From: [Symons, Brian D](#)
To: [Sager, John E - DNR](#)
Cc: [Gregory Prom \(MP\)](#); [Jamie Mehle \(SWLP\)](#); [Hughes, Erin](#); [Laszewski, Steve](#); [Saari, Christopher A - DNR](#)
Subject: RE: [EXTERNAL MAIL] SWL&P 100% Design
Date: Wednesday, December 28, 2022 5:16:49 PM
Attachments: [Attachments.html](#)

In the 90% Upland RAD comments, DNR requested nested piezometers with monitoring wells MW-3R and MW-4R and an additional monitoring well located near the City of Superior building in the area of SLIF-33. This e-mail is a response to DNR's e-mail dated December 27, 2022 regarding the nested monitoring wells and MW-29.

**UPLAND AREA REMEDIAL ACTION
 DESIGN DRAWINGS
 FOR THE
 FORMER MGP SITE**
SUPERIOR WATER, LIGHT & POWER
 WISCONSIN
 DOUGLAS COUNTY

CROSS-SECTIONS
 FORMER
 HORTONSHERE

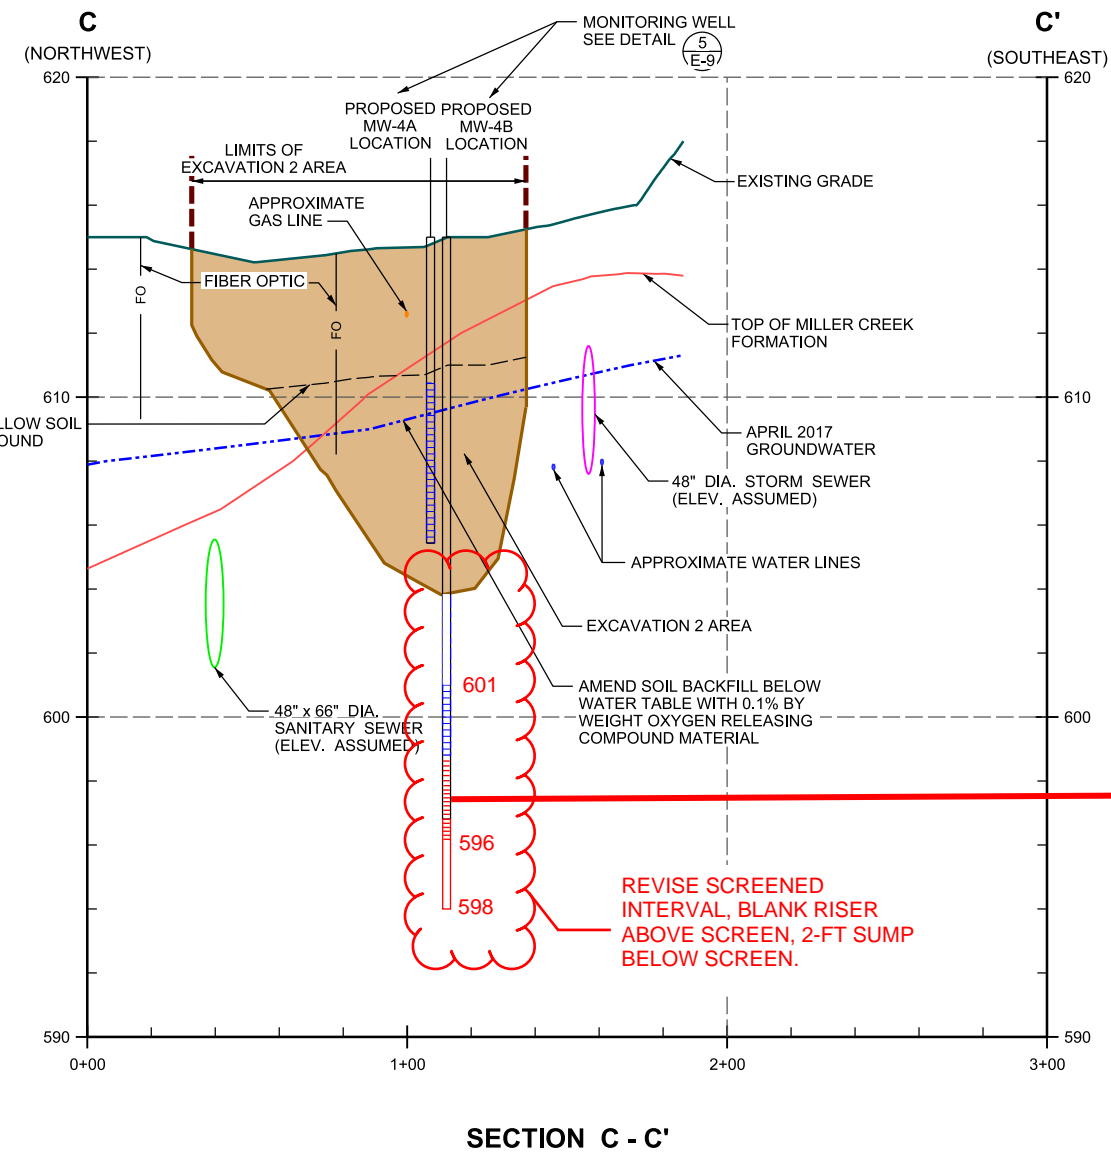
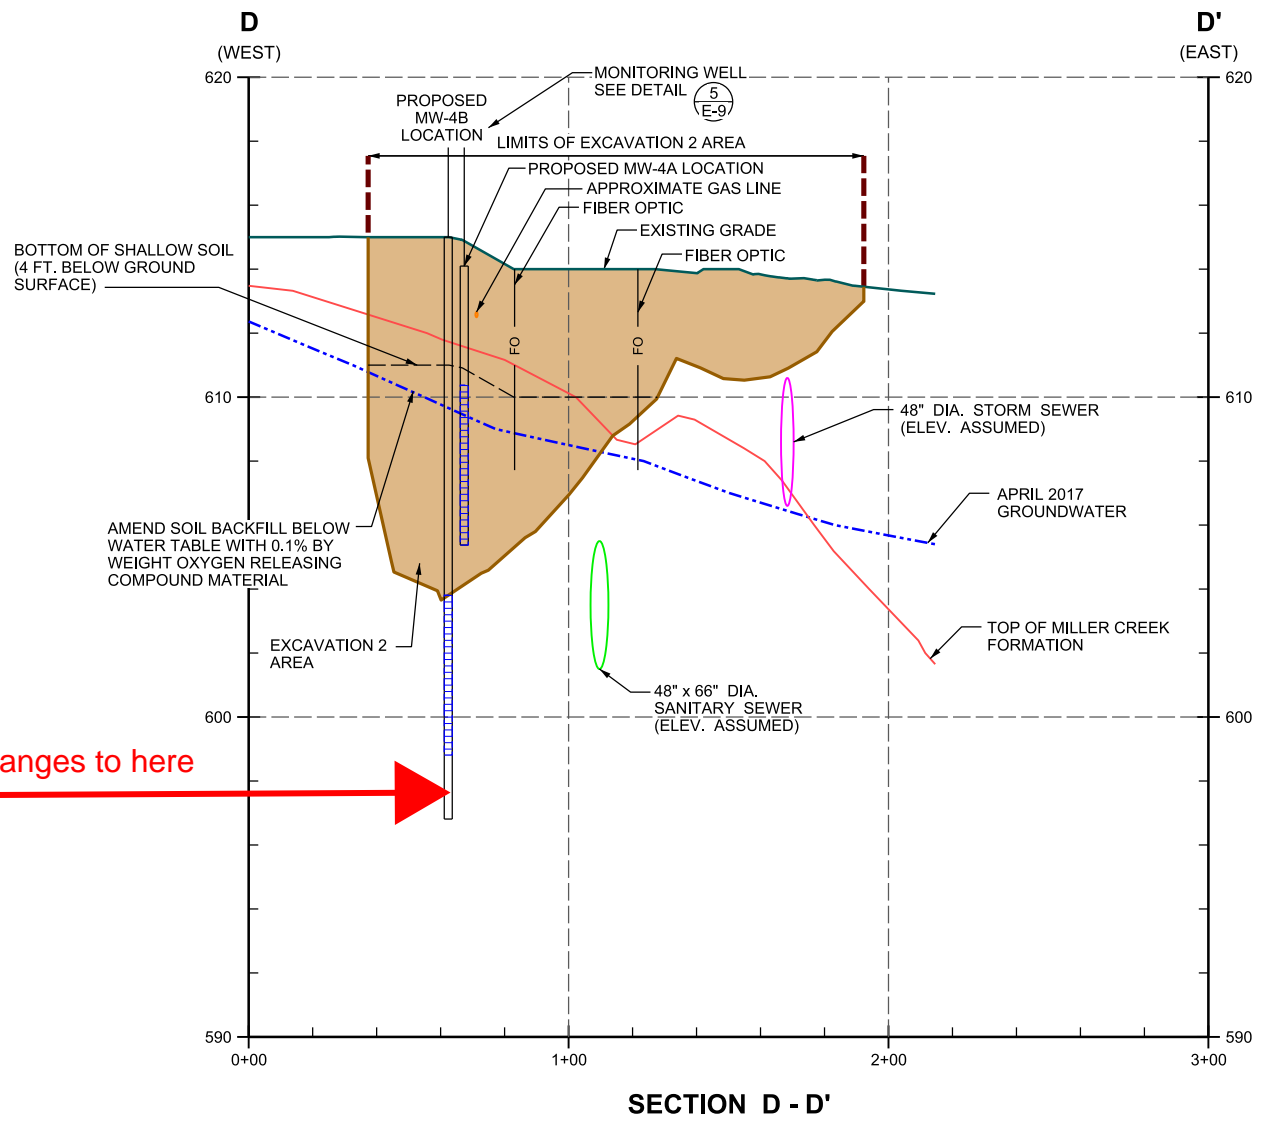
- the screened interval for MW-3B and MW-4B to be installed at approximately 596 to 601ft MSL adjusted to intersect sand layers, if present, and
- the location of MW-29 to be located further west near SLIF-33.

copy changes to here →

The changed figures look good except I am a little confused about Figure B-5 and B-6. They appear to be draft figures with notes for changes, not final figures (see below). The modifications look correct but please send me the final figures when they are available. Thank you.

- the cross-sections for MW-3B or MW-4B screened between 596 and 601 ft MSL (i.e., Drawings B-5 and B-6 in the RAD, ECSWMP, and OM&M Plan) and
- the location for B-29 near SLIF-33 (i.e., Drawing A-8 in the RAD, ECSWMP, and OM&M Plan; FSP Figure 4-1; and AMP Figure 2-1).

**LONG - TERM
 GROUNDWATER
 MONITORING
 NETWORK**

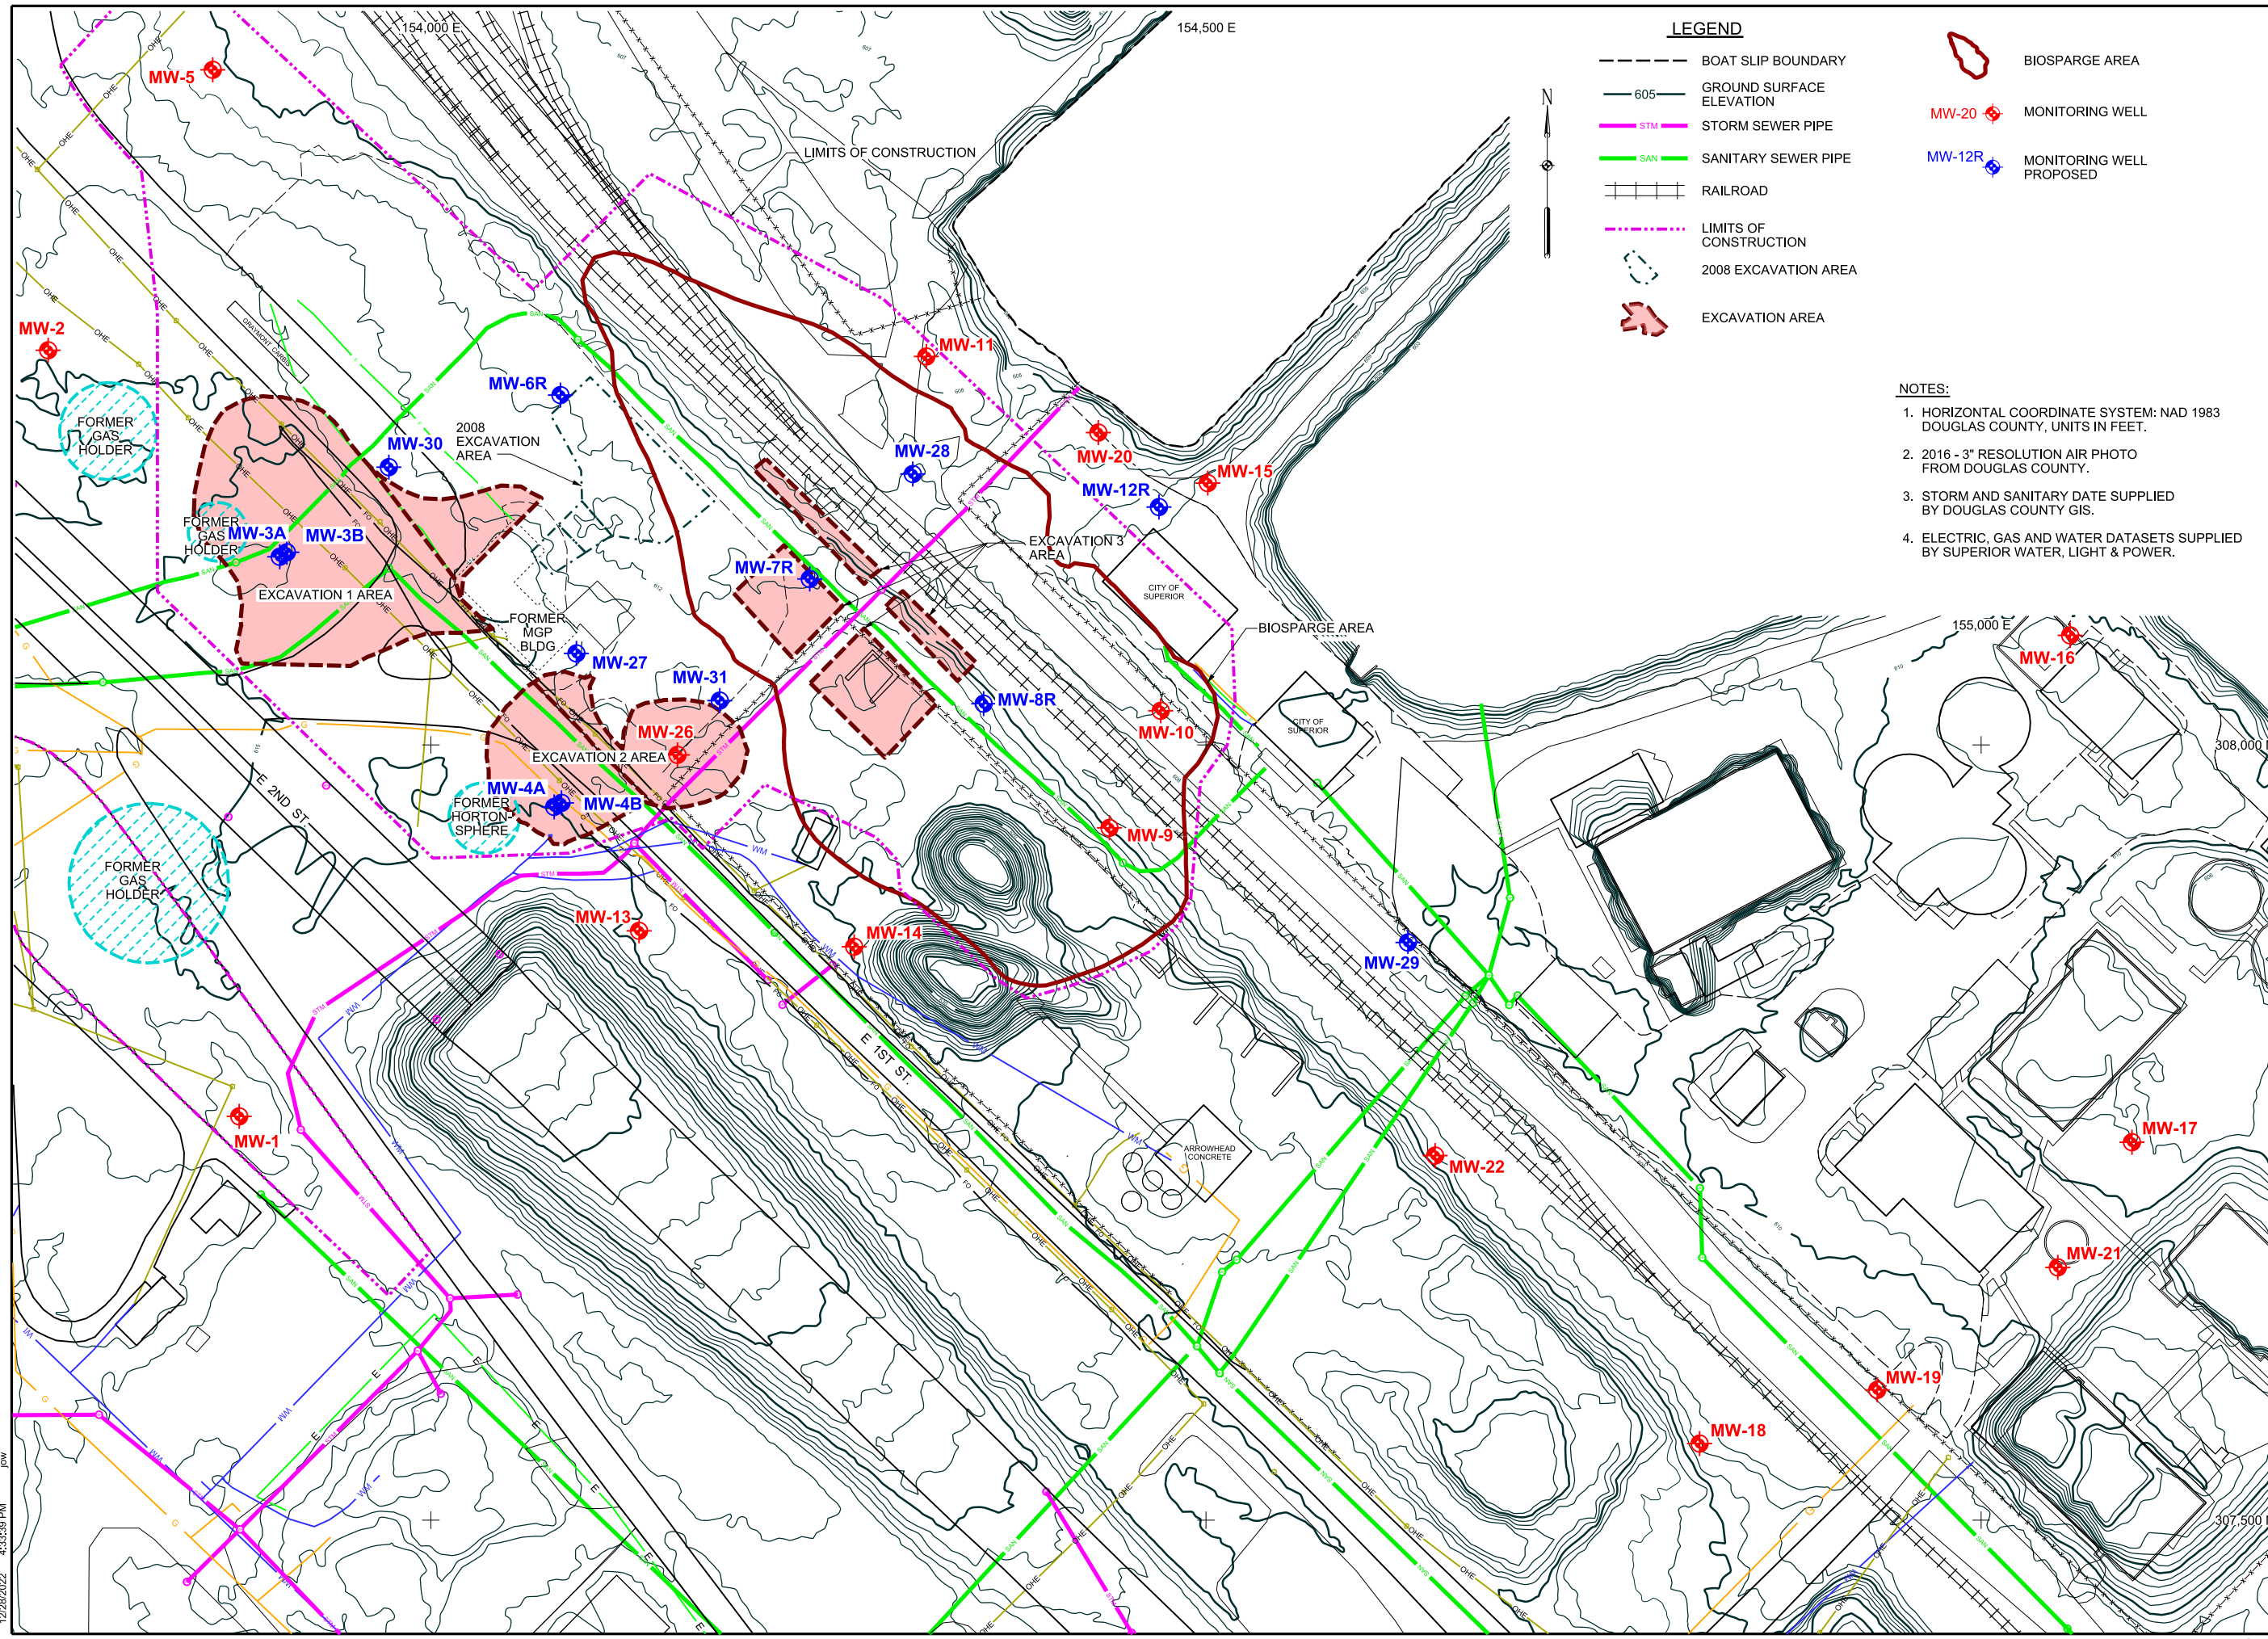
Figure 4-1 in Foth's Field sampling plan depicts the well in the same location as in the 90% design. Rather than delaying approval of the entire 100% design over this issue I would like written confirmation from SWL&P and Foth including a new Figure 4-1 depicting the locations

of the proposed monitoring well MW-29 in the location requested by DNR. If SWL&P and Foth would like to retain the location depicted then the DNR requests an additional monitoring well near the location of SLIF-33. If this issue is not addressed it may delay DNR issuing approval of the 100% design report.

CROSS-SECTIONS FORMER MGP GAS HOLDER

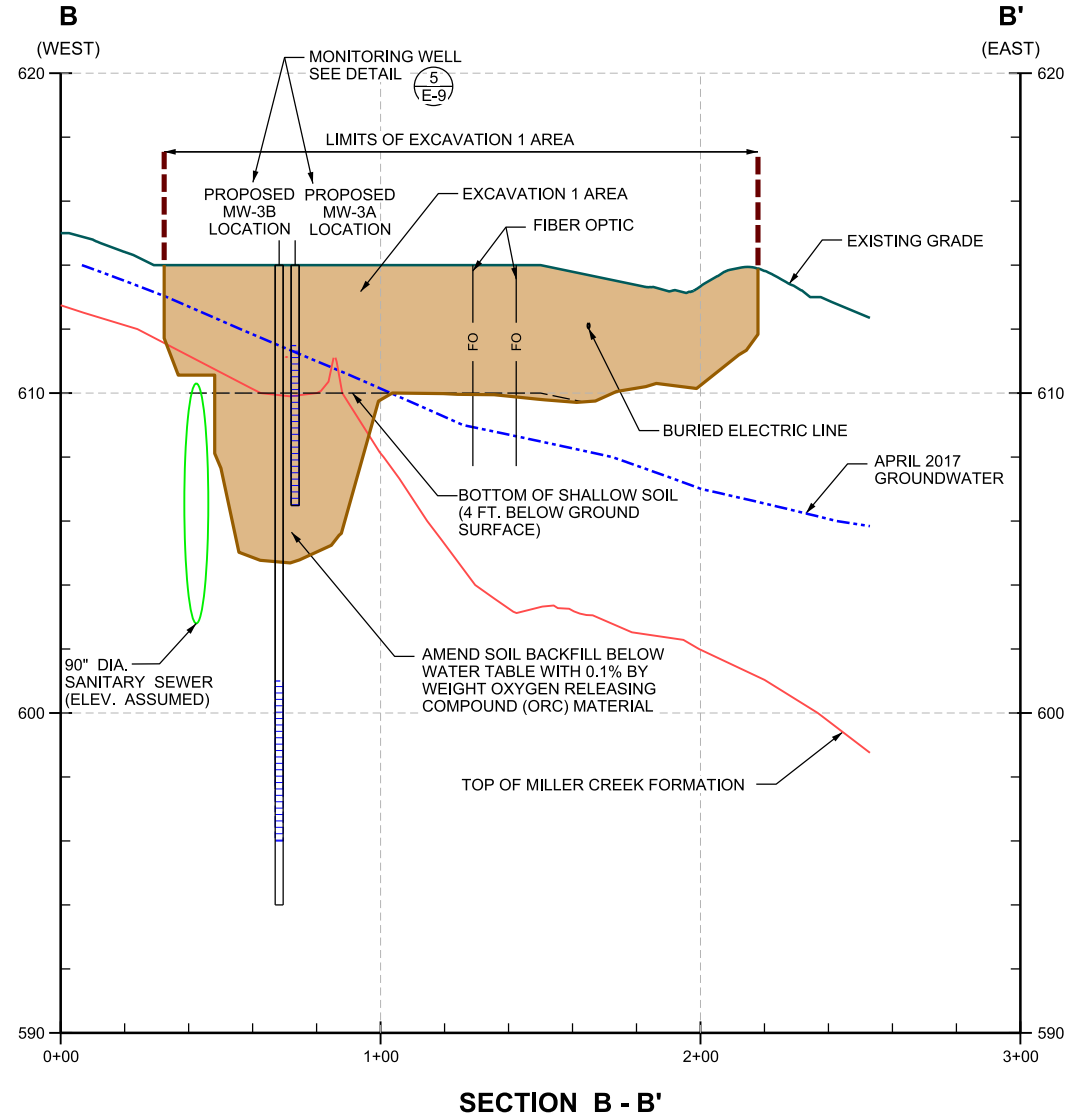
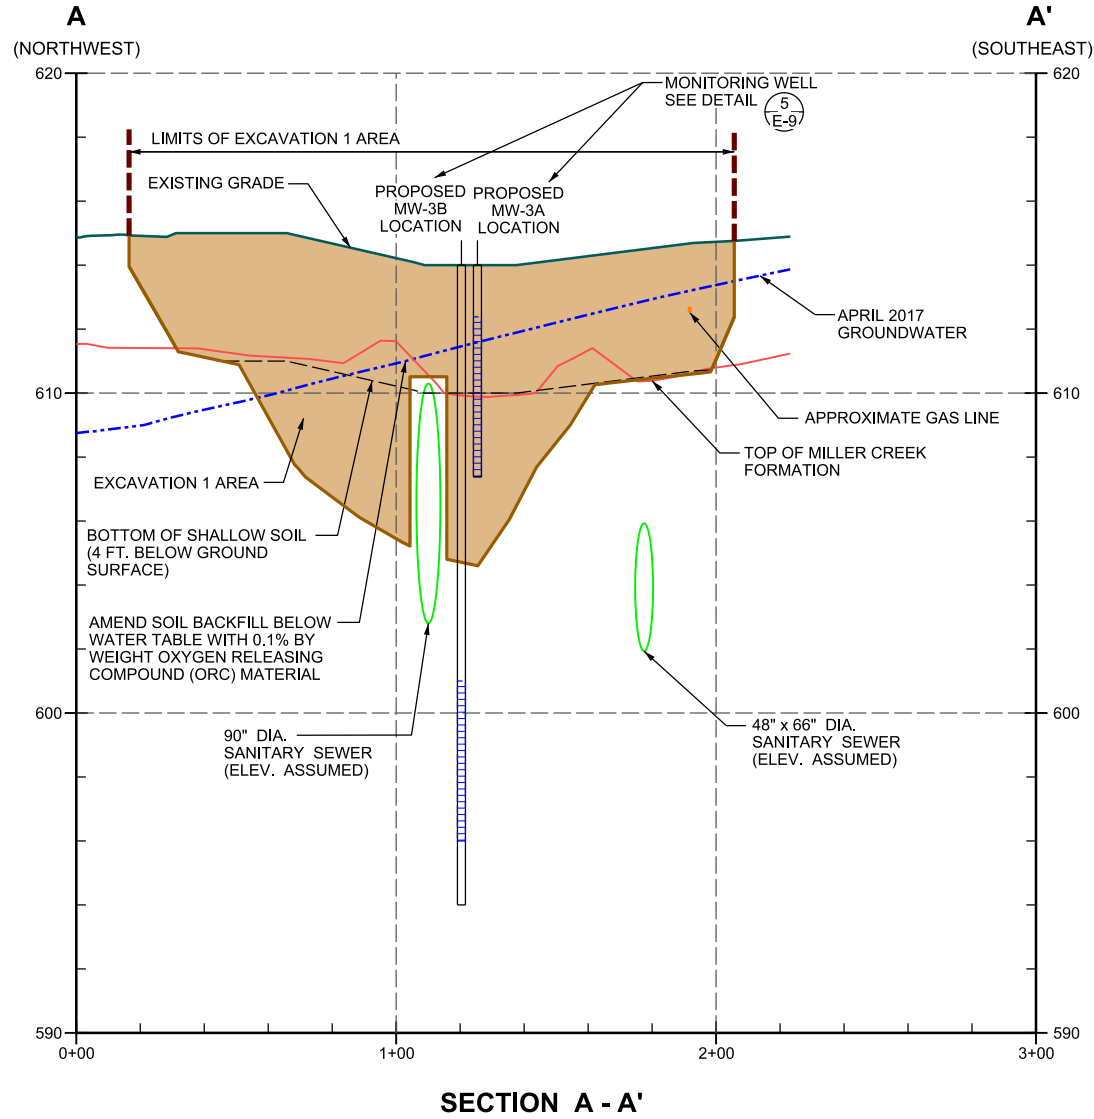
- the screened interval for MW-3B and MW-4B to be installed at approximately 596 to 601ft MSL adjusted to intersect sand layers, if present, and
- the location of MW-29 to be located further west near SLIF-33.

Final Drawings B-5 and B-6 are attached below.

- the cross-sections for MW-3B or MW-4B screened between 596 and 601 ft MSL (i.e., Drawings B-5 and B-6 in the RAD, ECSWMP, and OM&M Plan) and
- the location for B-29 near SLIF-33 (i.e., Drawing A-8 in the RAD, ECSWMP, and OM&M Plan; FSP Figure 4-1; and AMP Figure 2-1).
